Airport East Precinct

Addendum review of environmental factors

Airport East Precinct project
Addendum review of environmental
factors

March 2017

FIGURE 2-2: Joyce Drive / General Holmes Drive / Ross Smith Avenue intersection

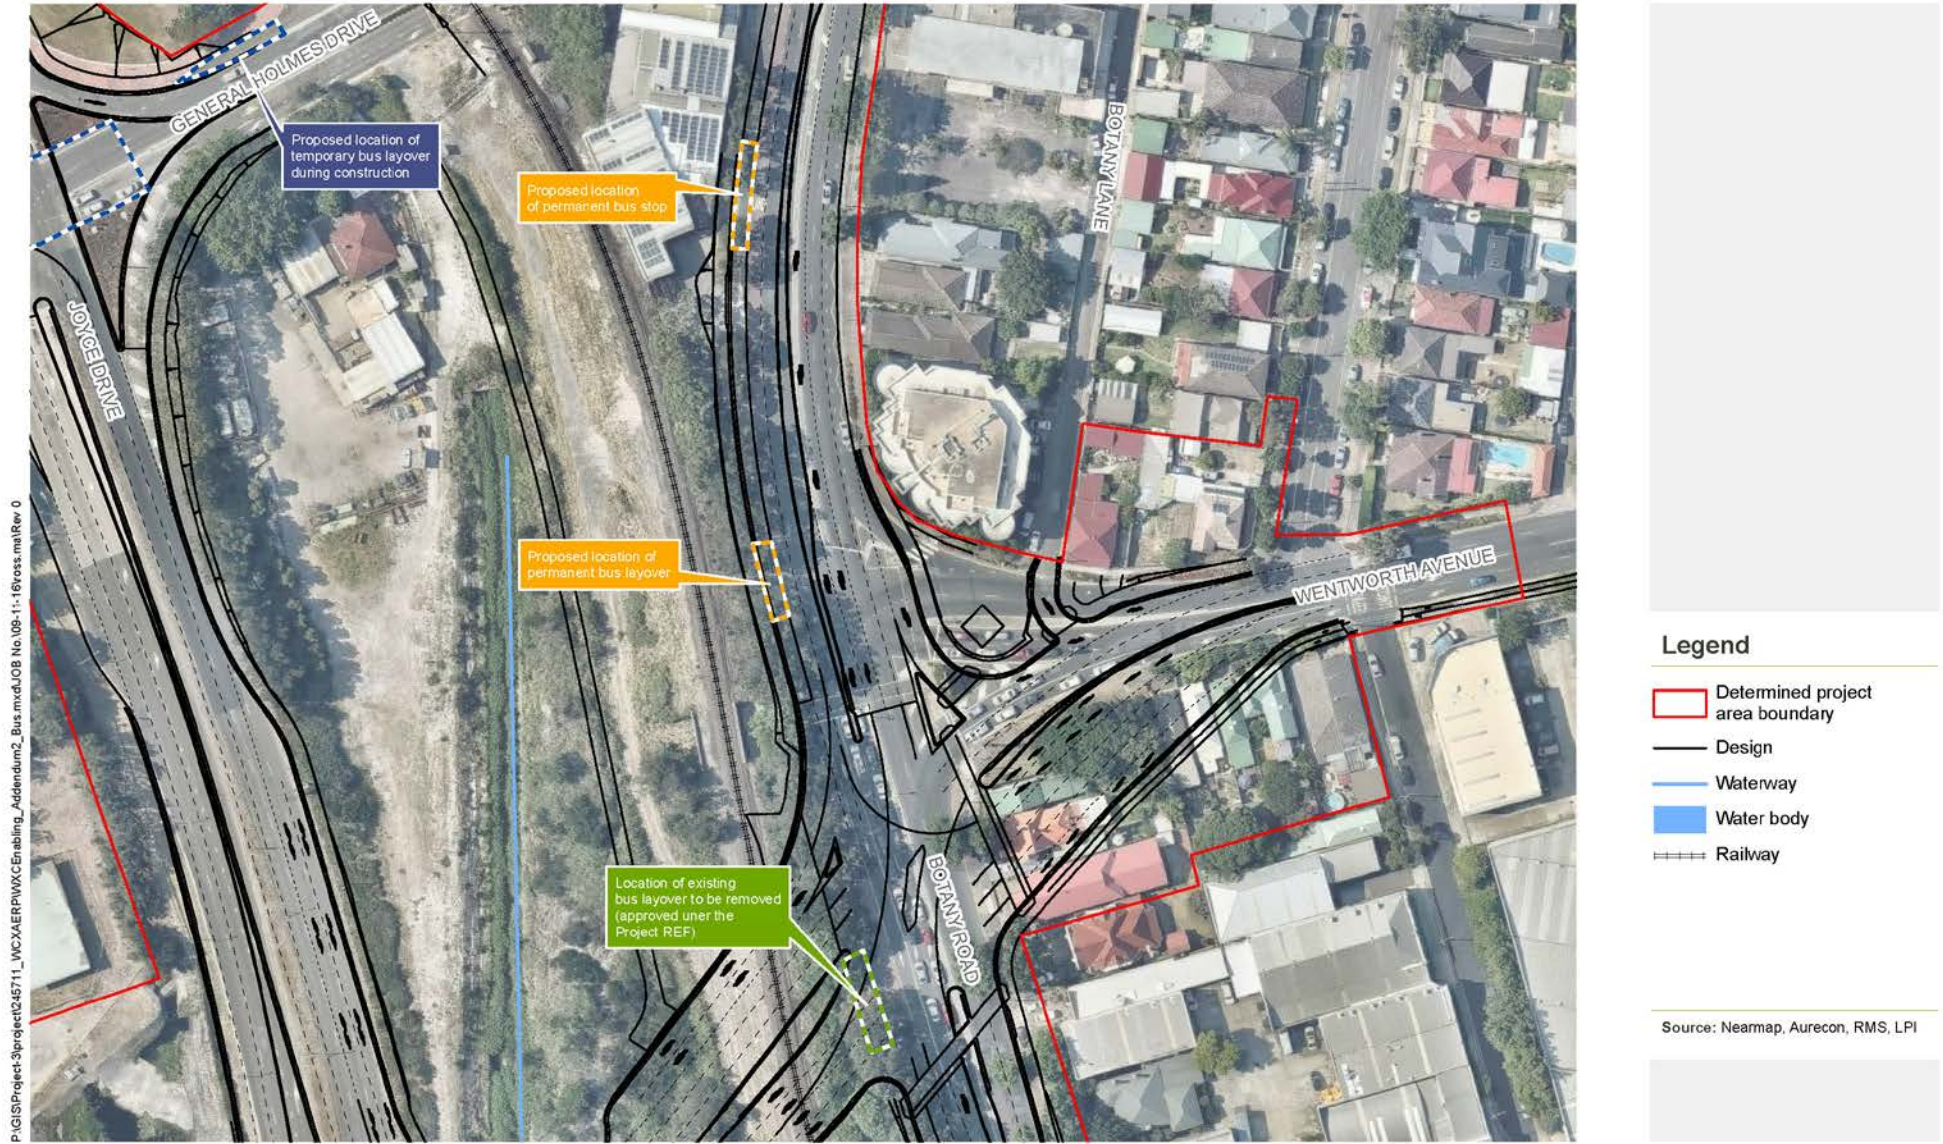
The Project REF assessed the widening of the median at the intersection of Joyce Drive and General Holmes drive to allow for a future right turn lane into Ross Smith Avenue. The revised proposal involves reducing the width of the median to incorporate a dedicated right hand turn lane for southbound traffic turning into Ross Smith Avenue.

For vehicles travelling west from SACL and ARTC land (the former level crossing location), the revised proposal incorporates one left slip lane onto General Holmes Drive, one shared through and right hand turn lane and one dedicated right hand turn lane onto Joyce Drive.

FIGURE 2-5: Electrical and communications conduits

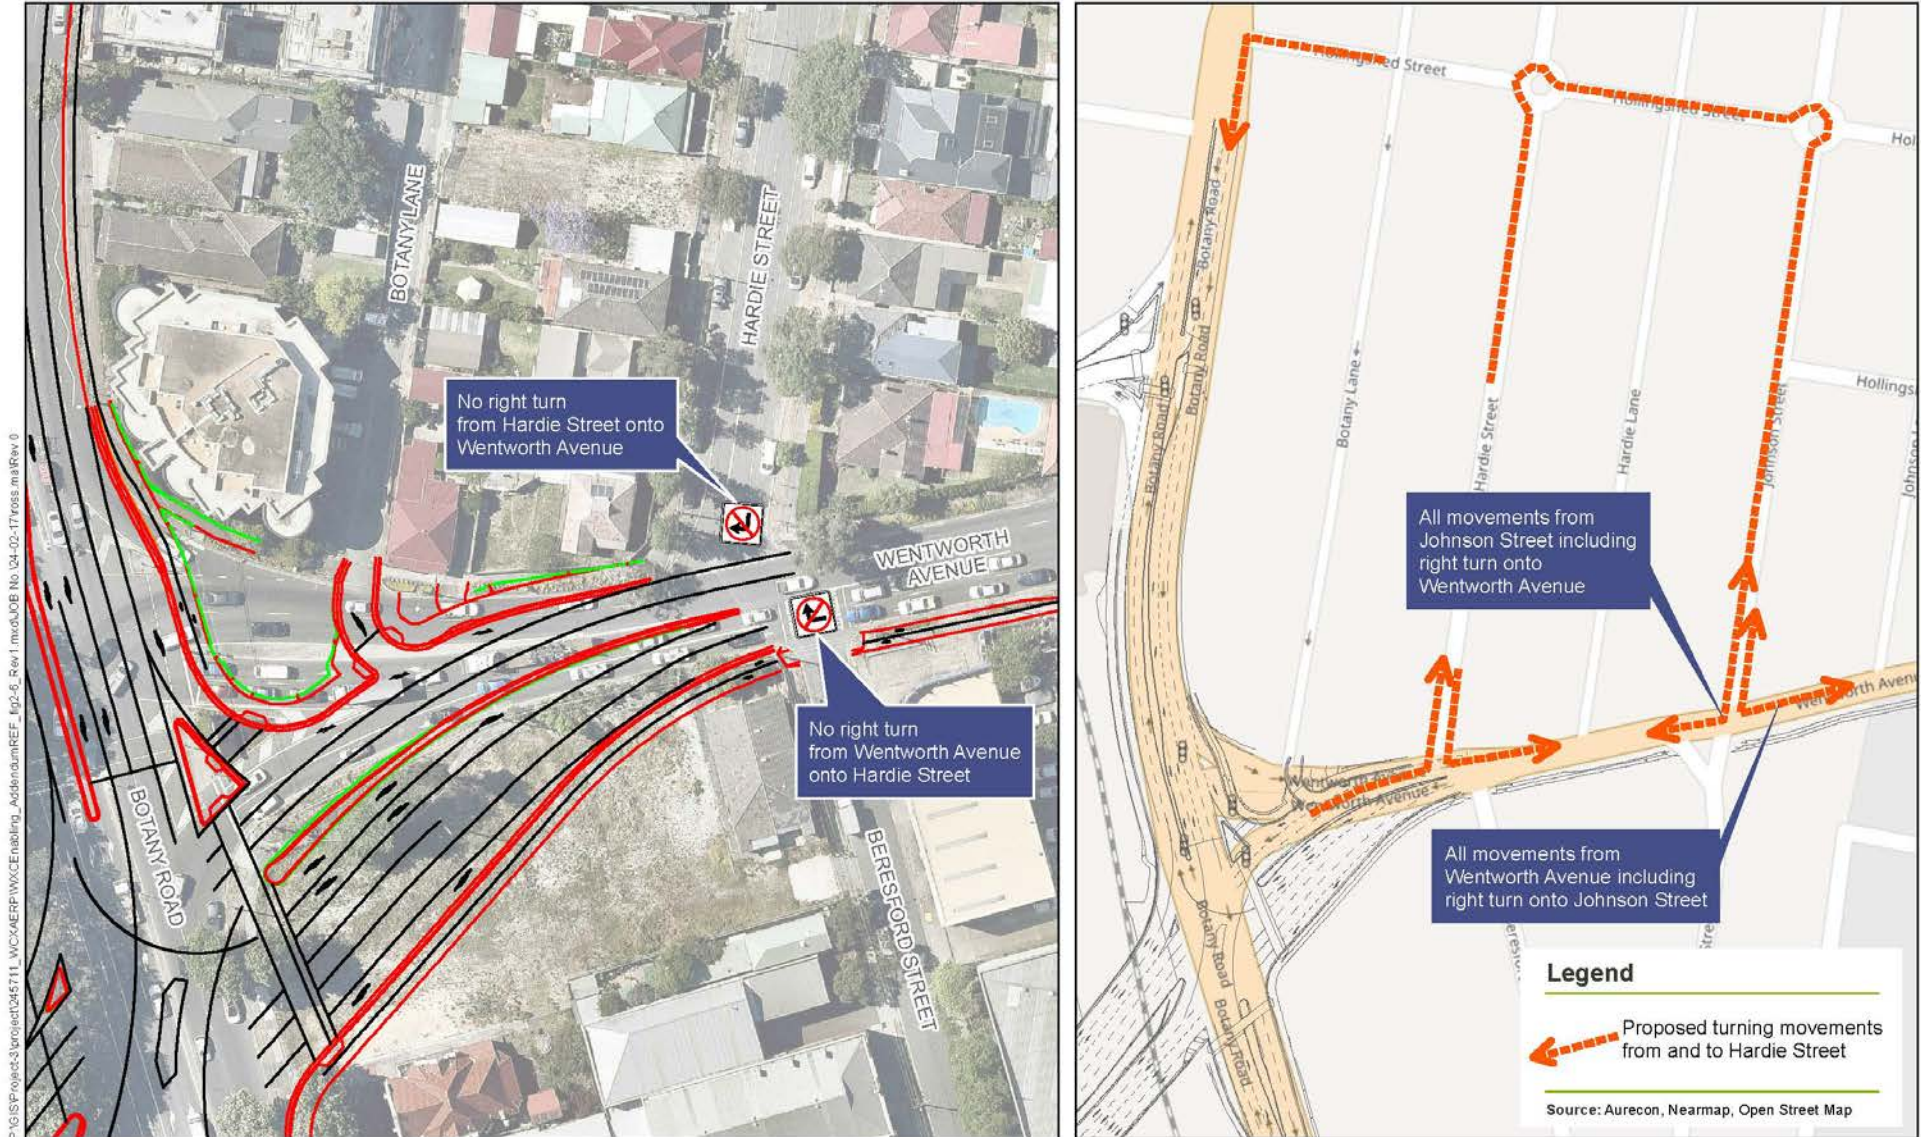
The addendum REF (April, 2016) made provision for the installation of additional ITS conduits for a new VMS which were outside the determined project area. The revised proposal includes the installation of additional communications and electrical conduits into new underground infrastructure. The conduits would cross under Southern Cross Drive and be connected to existing pits and cabinets. The final design and construction methodology will be determined by the contractor however it is assumed that the installation will be via open trenching. This activity would result in some excavation to the east of Southern Cross Drive and associated clearing of a grassed verge area. This activity is outside the approved project area.

FIGURE 2.6: Wentworth Avenue and Hardie Street intersection

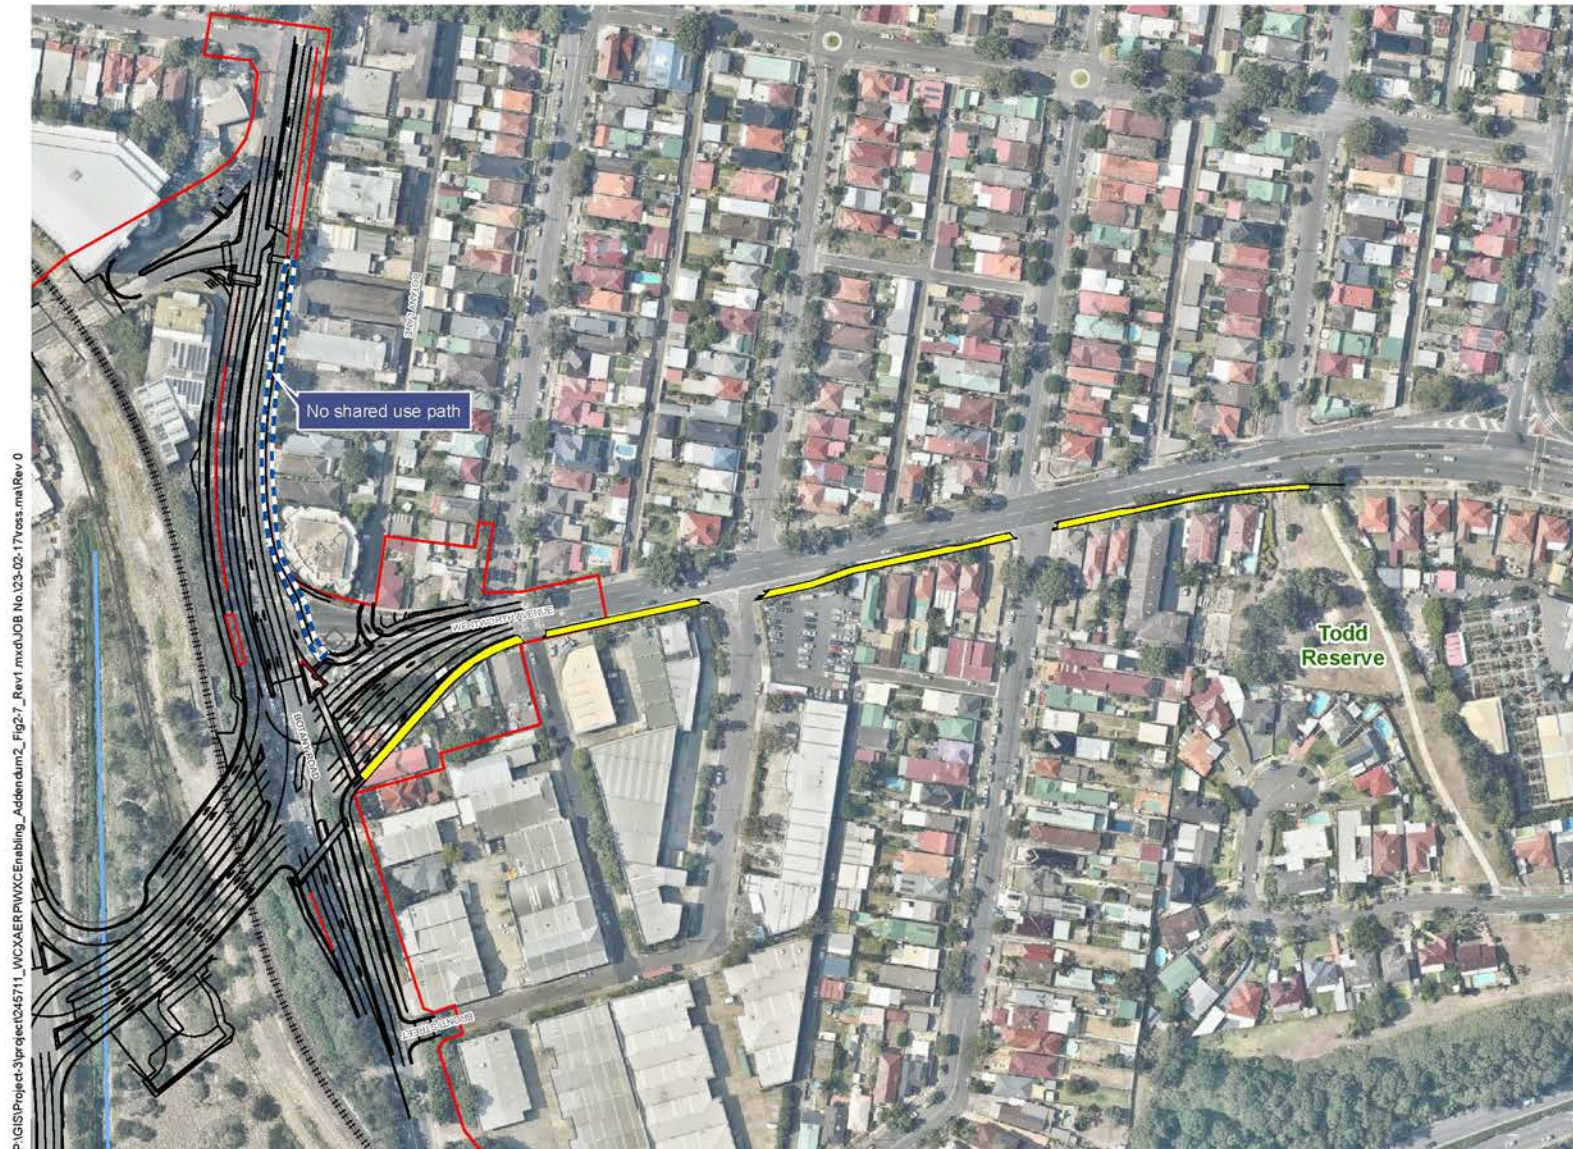
Revised traffic movements at the Wentworth Avenue and Hardie Street intersection

The introduction of a concrete median to separate the different direction of traffic at the Wentworth Avenue / Botany Road intersection would impact on the ability to make a right hand turn from / to Wentworth Avenue. As such, the Wentworth Avenue / Hardie Street intersection will become a left-in / left-out only intersection.

FIGURE 2-7: Shared use path along Botany Road

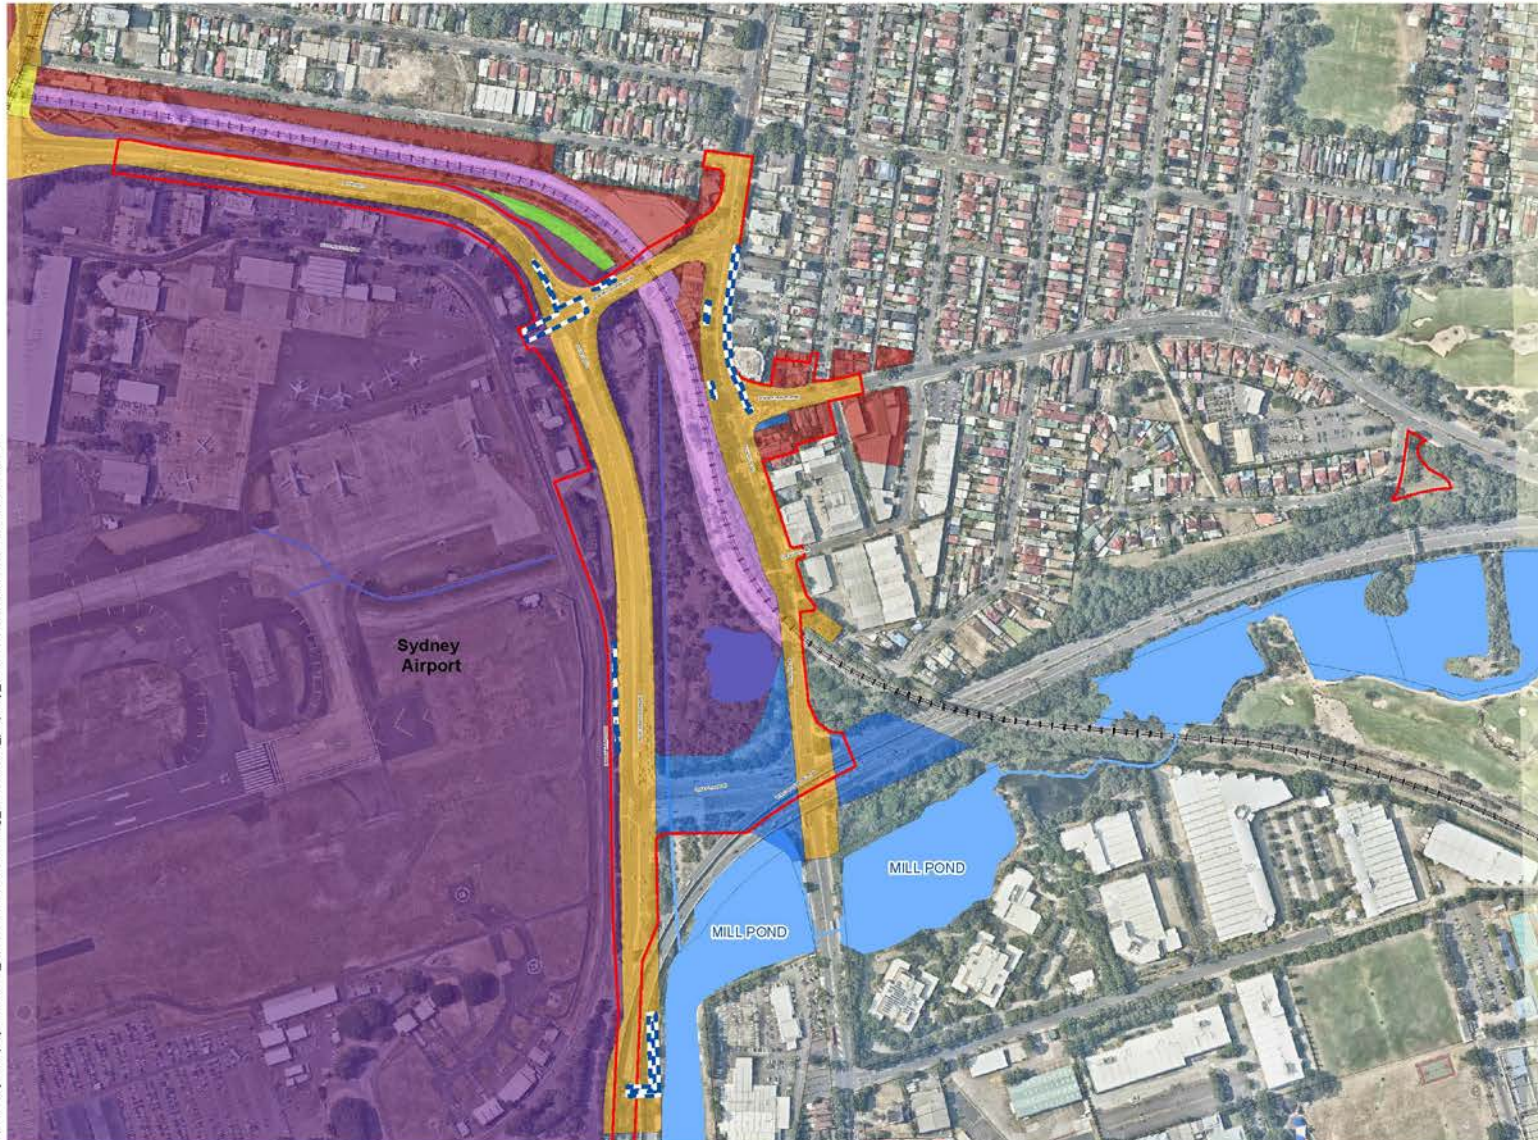
The Project REF identified the construction of about 130 metres of shared use path along Botany Road, from north of the Wentworth Avenue / Botany Road intersection to General Holmes Drive (former level crossing). This would have required the widening of the existing pedestrian footpath, removal of a number of mature street trees and relocation of utility assets (light poles).

The shared use path would not be able to be constructed due to a lack of appropriate space (a minimum of two metres is required) from existing utility assets and a current development application for an alfresco area adjoining the existing pedestrian footpath. The project will still include a shared use path along the southern edge of Wentworth Avenue from Todd Reserve to Botany Road. A pedestrian crossing is located across Wentworth Avenue at Botany Road. Under the revised proposal, the shared use path would tie into the upgraded pedestrian footpath along the eastern side of Botany Road between Wentworth Avenue and General Holmes Drive (former level crossing). Access would then be along Baxter Road (shared use path to be constructed as part of another project) and O'Riordan Street.
